SERVICE BULLETIN

ENGINE - STAGE 1 HIGH PRESSURE TURBINE VANE CLUSTER ASSEMBLY - PROVIDE A MODIFICATION OF STAGE 1 HPT VANE ASSEMBLIES - CATEGORY CODE 8 - MOD.ENG-72-0312

V2500-ENG-72-0312

Location of the Stage 1 HPT Vane Cluster Assembly
Fig.1

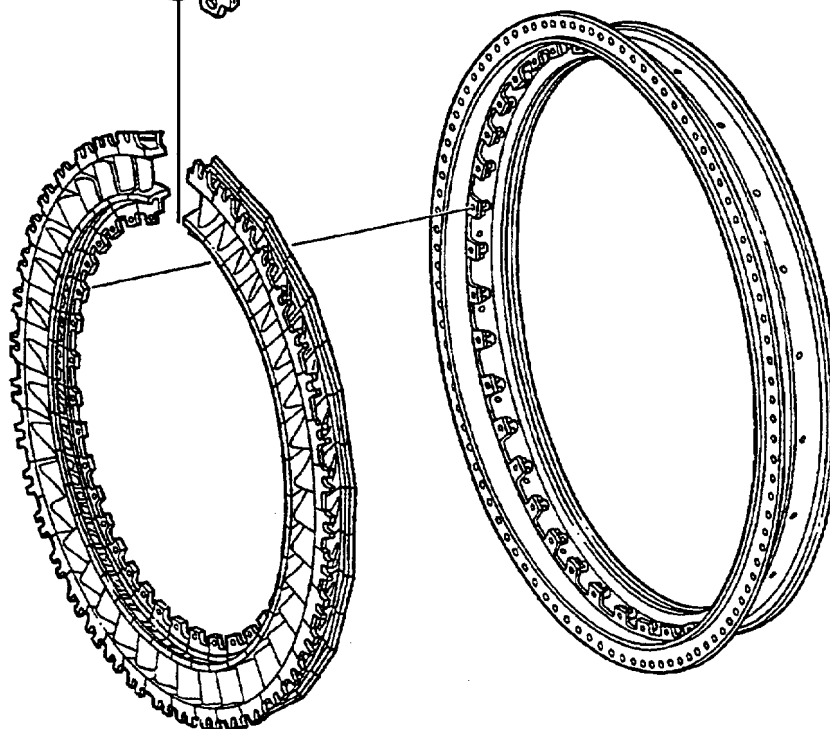
SEND THE APPLICABLE 2A0091 OR
2A2591 STAGE 1 HPT VANE CLUSTER
ASSEMBLIES TO AN AUTHORIZED
REWORK VENDOR

Family Tree - Stage 1 High Pressure Turbine Vanue Cluster Assembly Ref. Catalog
Sequence No. 72-44-20. Fig. 01 Items 250 Through 286
Fig.2

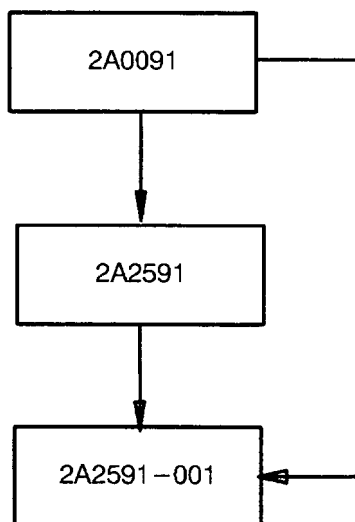
V2500-ENG-72-0312
ENGINE - STAGE 1 HIGH PRESSURE
TURBINE VANE CLUSTER ASSEMBLIES -
PROVIDE A MODIFICATION OF THE
STAGE 1 HPT VANE CLUSTER
ASSEMBLIES

PART NUMBER CHANGE
